**Great Brighams Mead.
Reading**

**Proposed Amendments to
Bike and Bin Storage**

5025893_GBM_1000_A

Figure 1-1. Cosented ground floor plan, drawing GBM_100_P02_Proposed Ground Floor Plan

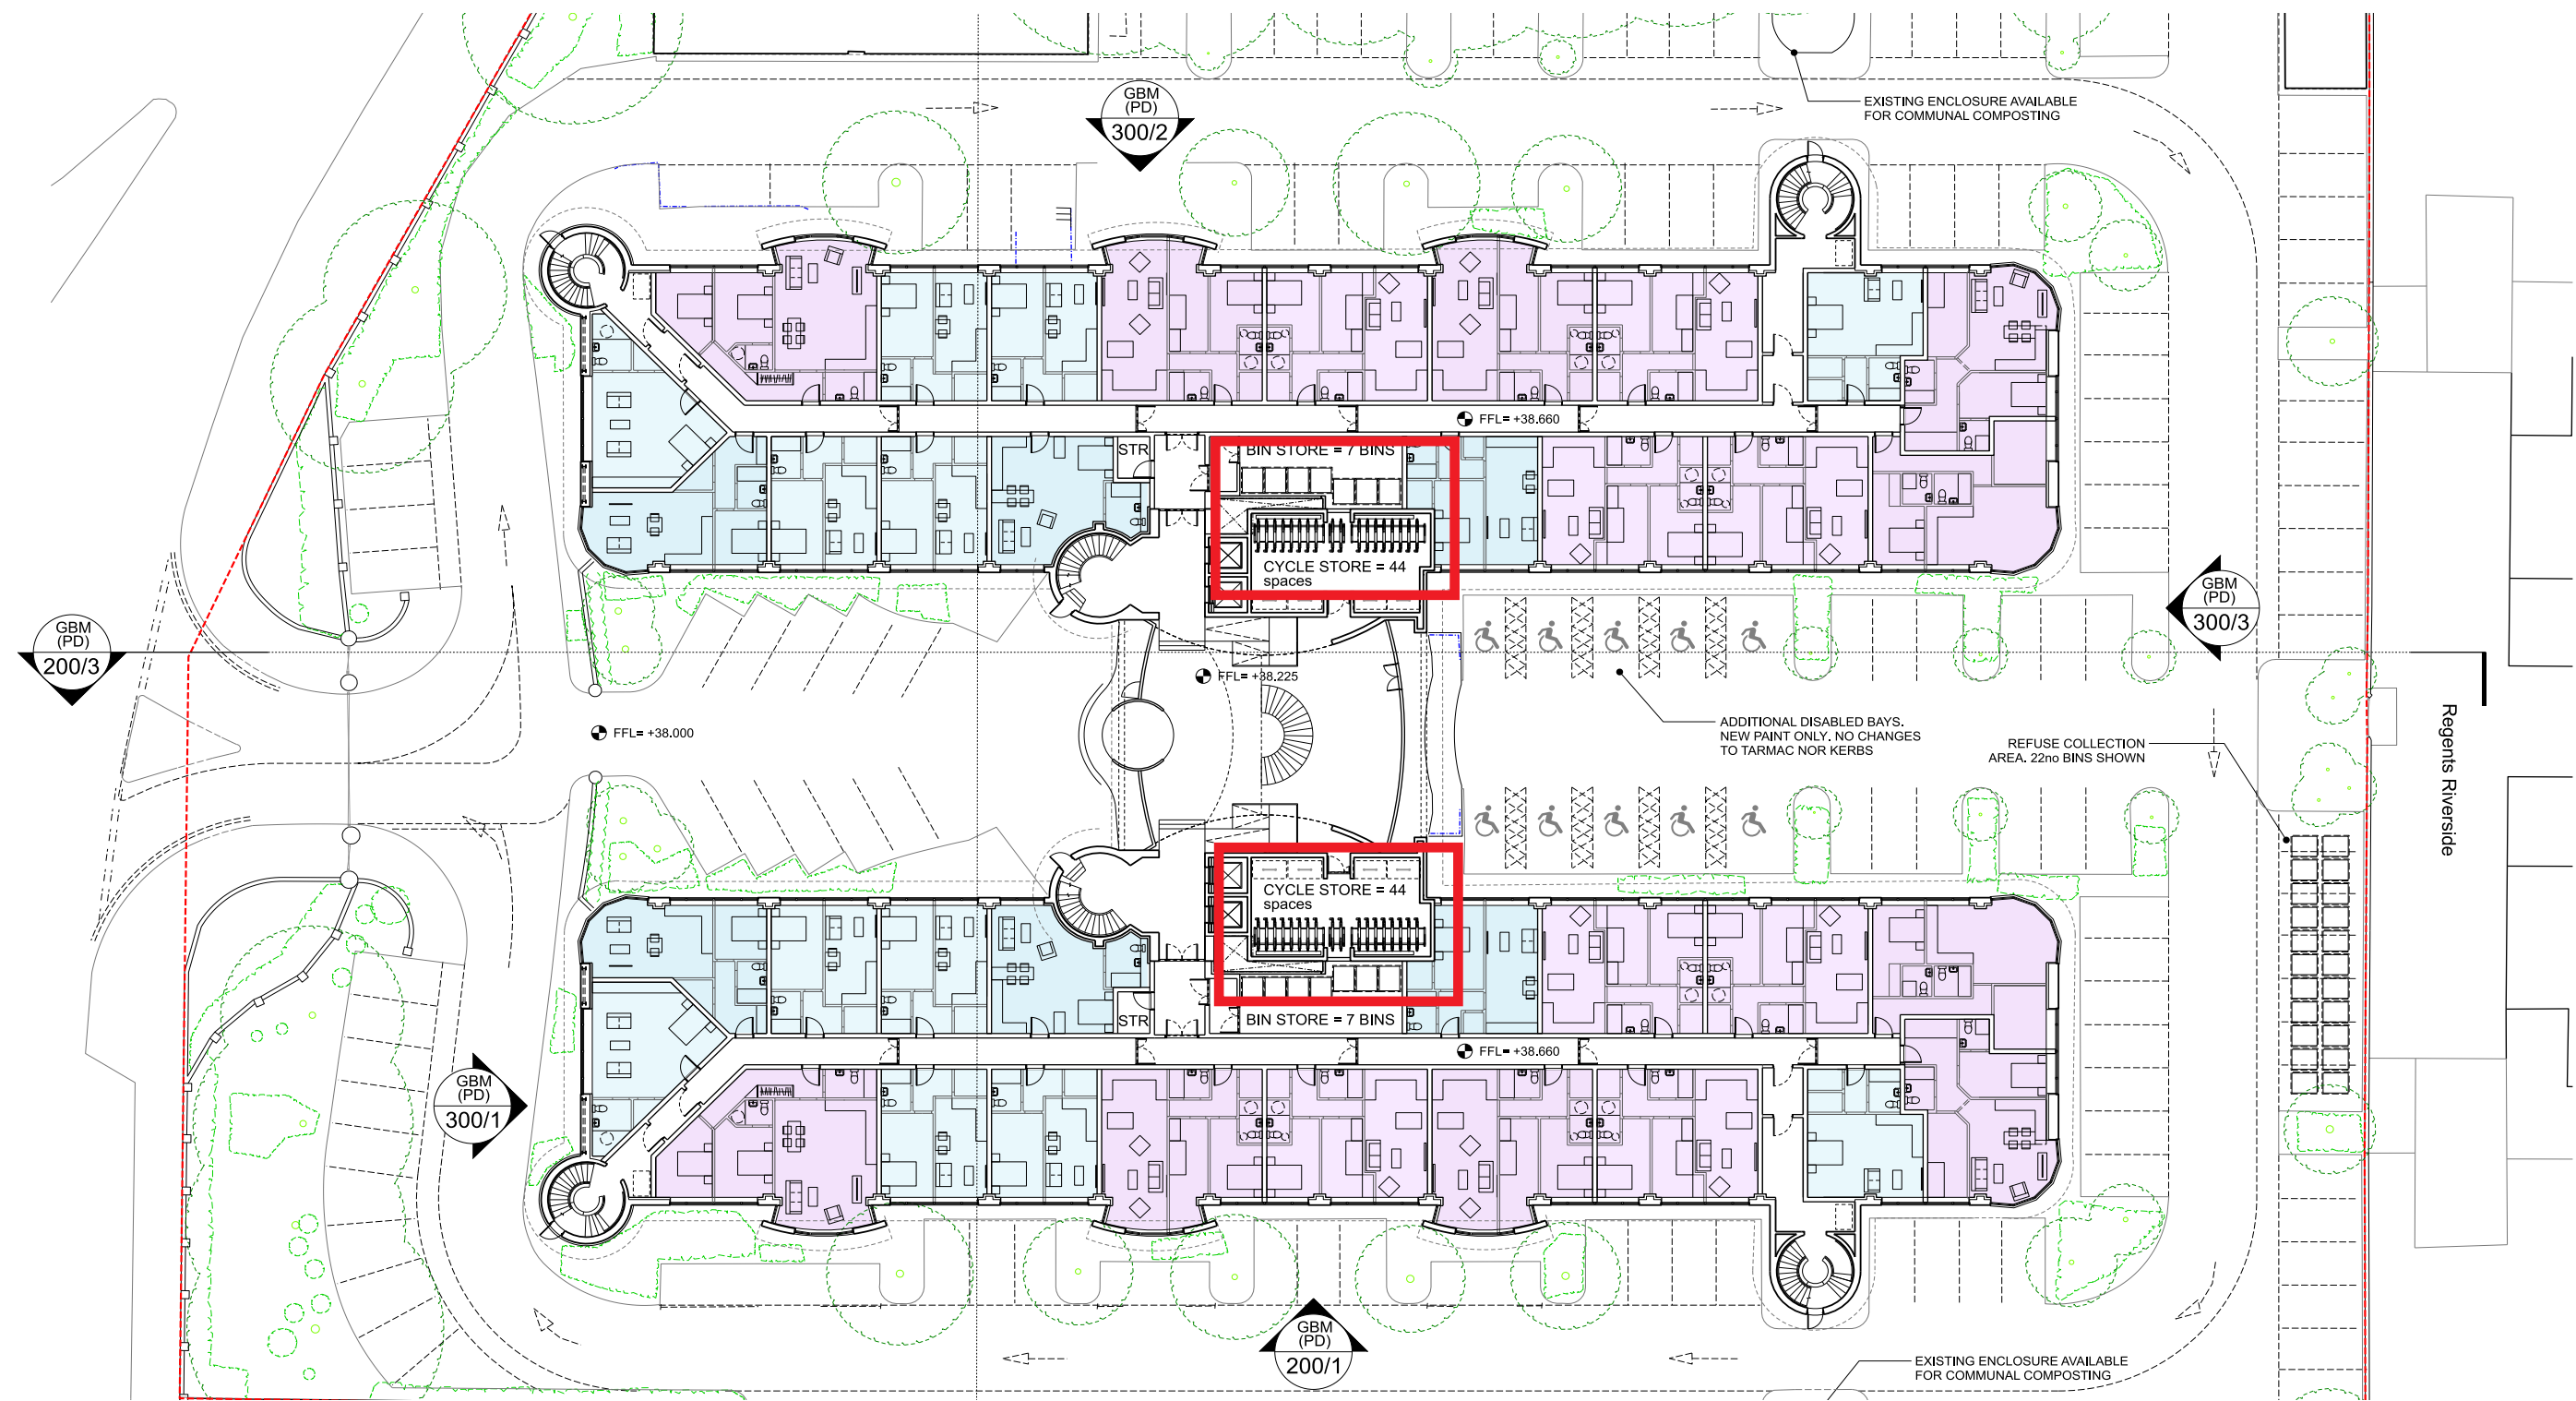
Original scheme;

88 bike spaces located in two separate stores using two-tier bike racks.

Proposed scheme;

90 bike spaces located in four separate stores using a single, wall mounted racking system;

- 50 bikes at ground level
- 40 bikes at first floor level

All four lifts are of a size capable of accommodating bicycles.

Figure 1-5. Cosented ground floor plan, drawing GBM_100_P02_Proposed Ground Floor Plan

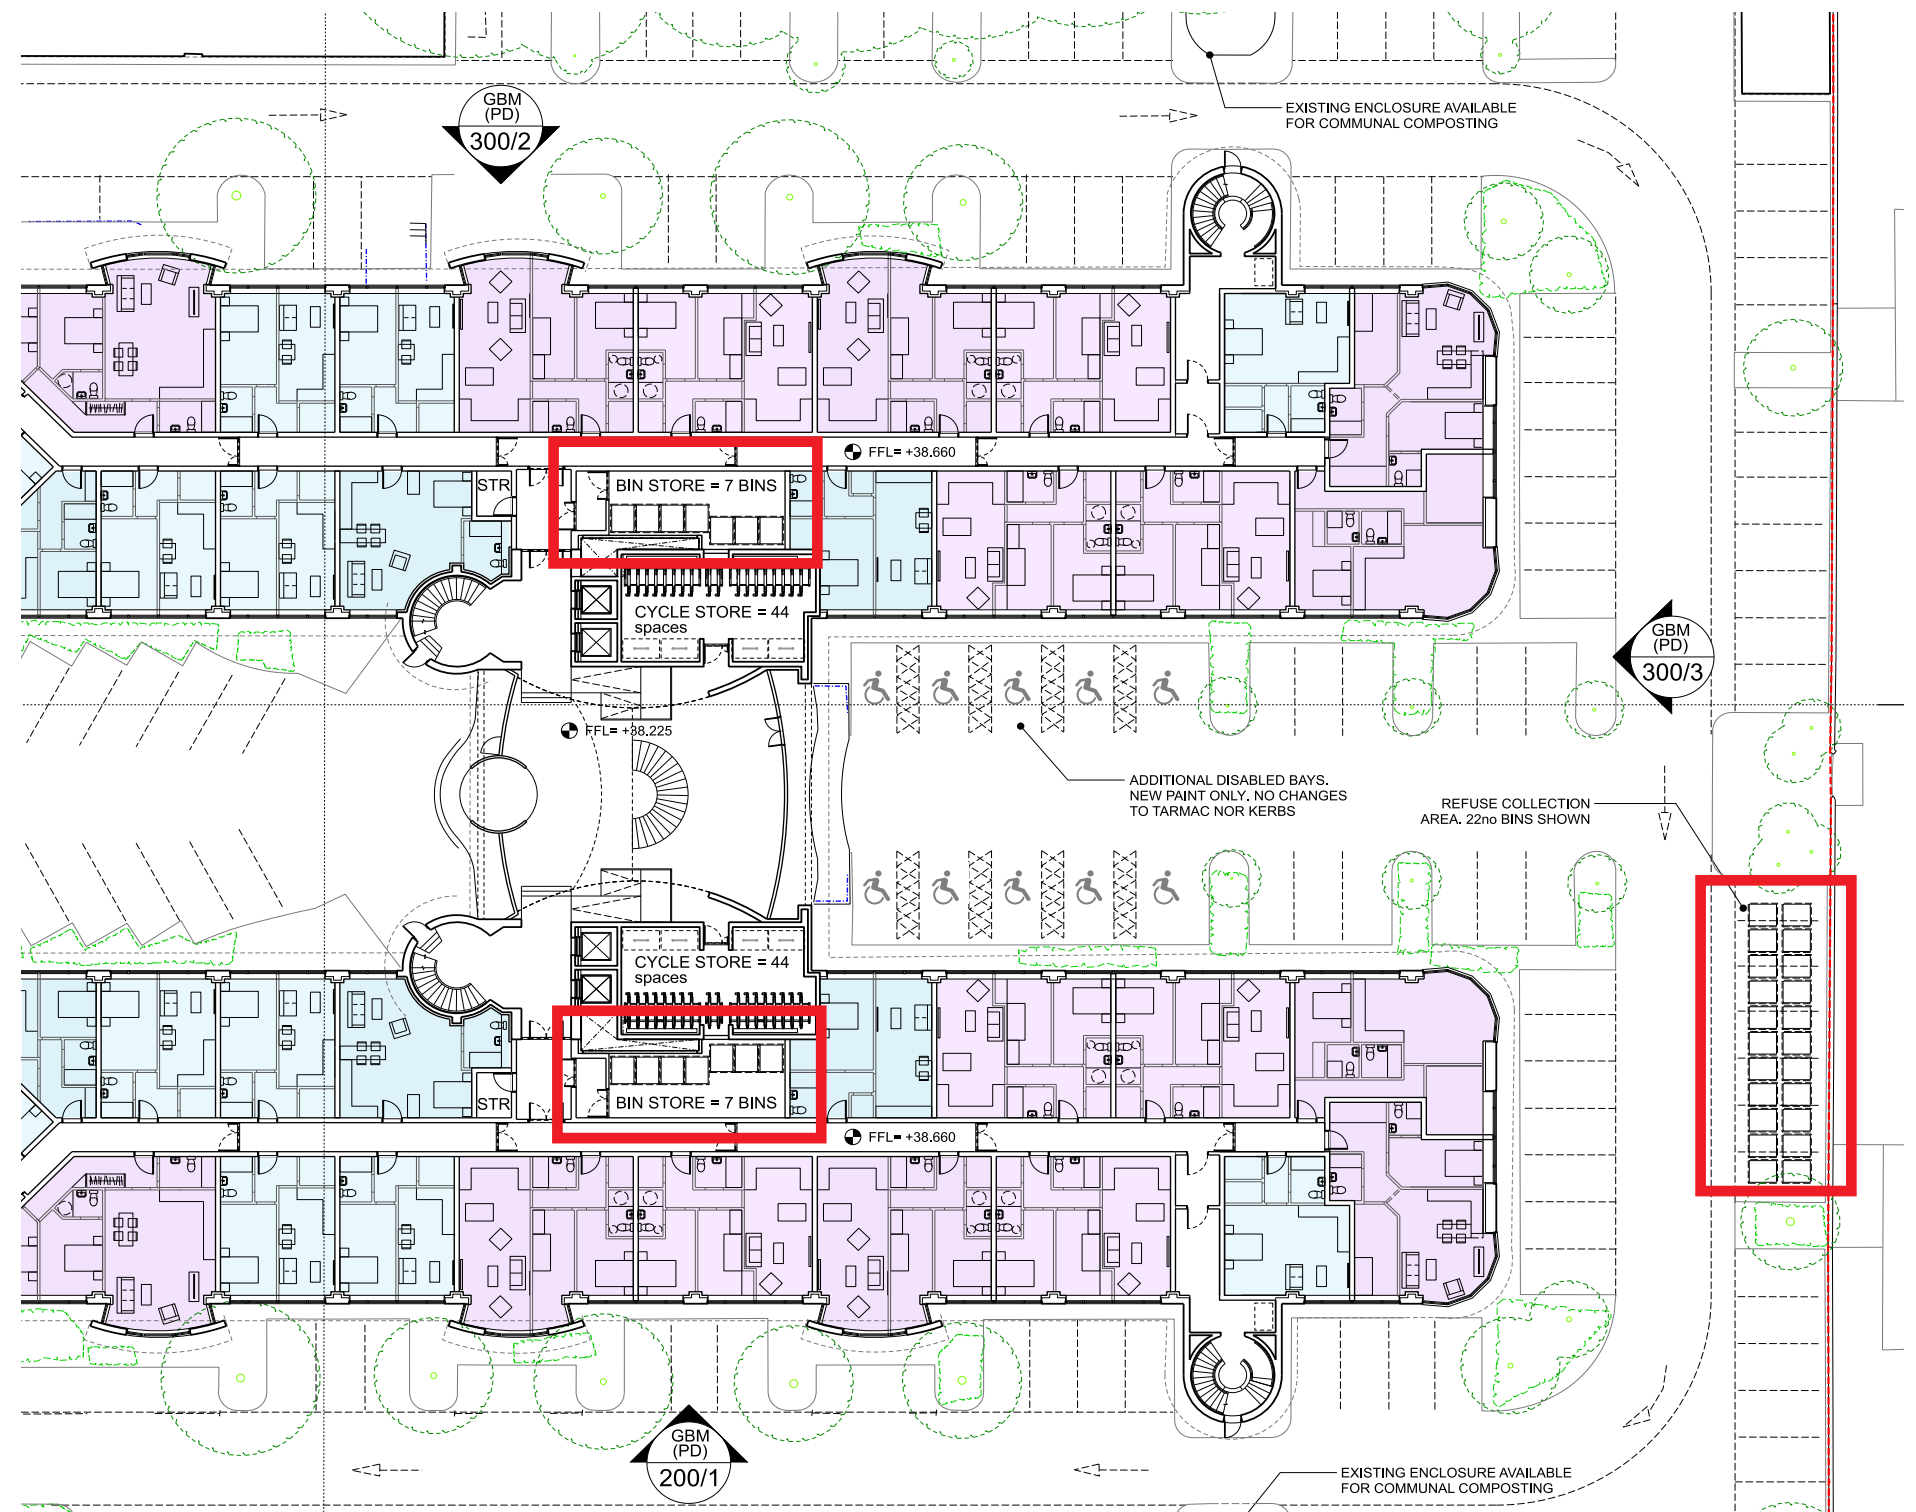
Original scheme;

36 x 1100 litre waste bins, with 14 located internally and 22 externally.

The bins stored internally are required to be moved down a switch-back ramp to get outside.

The previous scheme would seem to have under-provided waste provision.

Figure 1-6. Proposed ground floor plan, drawing 5025893-RDG-00-PLD-B-0305-E_Proposed Ground Floor Plan

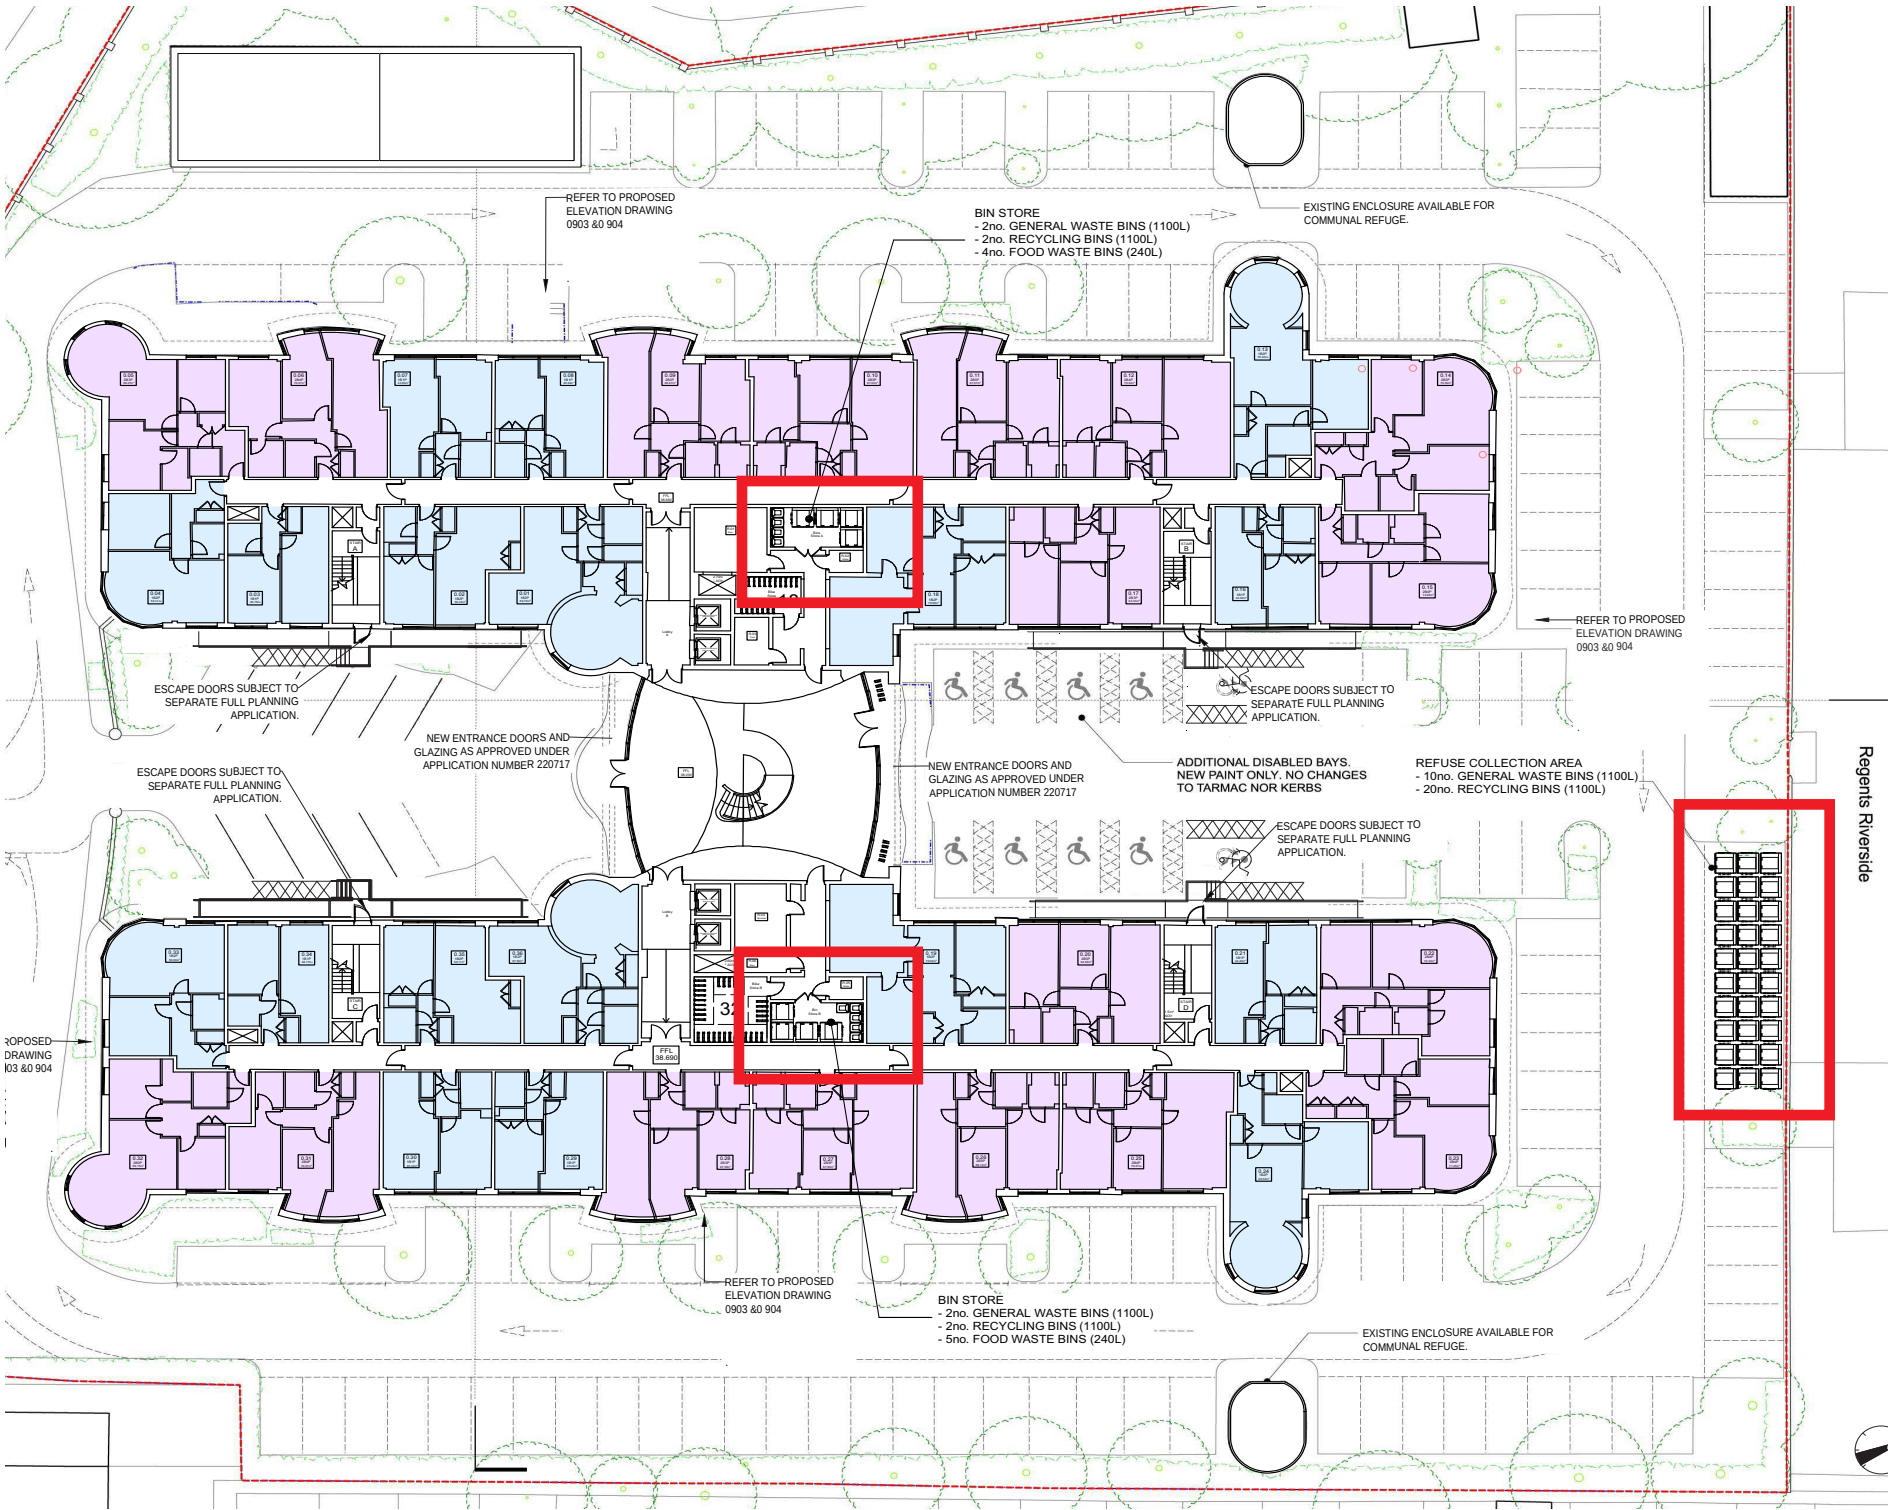
The proposed scheme;
At ground floor level, 8 x 1100 litre waste bins and 9 x 240 litre food waste bins are located in two dedicated bin stores. Bins located within the stores will be moved by the Facilities Management Team on a daily basis, and replaced with empty bins located within the bin collection area, located towards the northern boundary of the site. Externally there are 30 x 1100 litre waste bins located in the bin collection area.

In summary, the following provision is being made;
- 14 x 1100 litre general waste bins
- 24 x 1100 litre recycling bins
- 9 x 240 litre food waste bins
This is in line with the council’s requirements
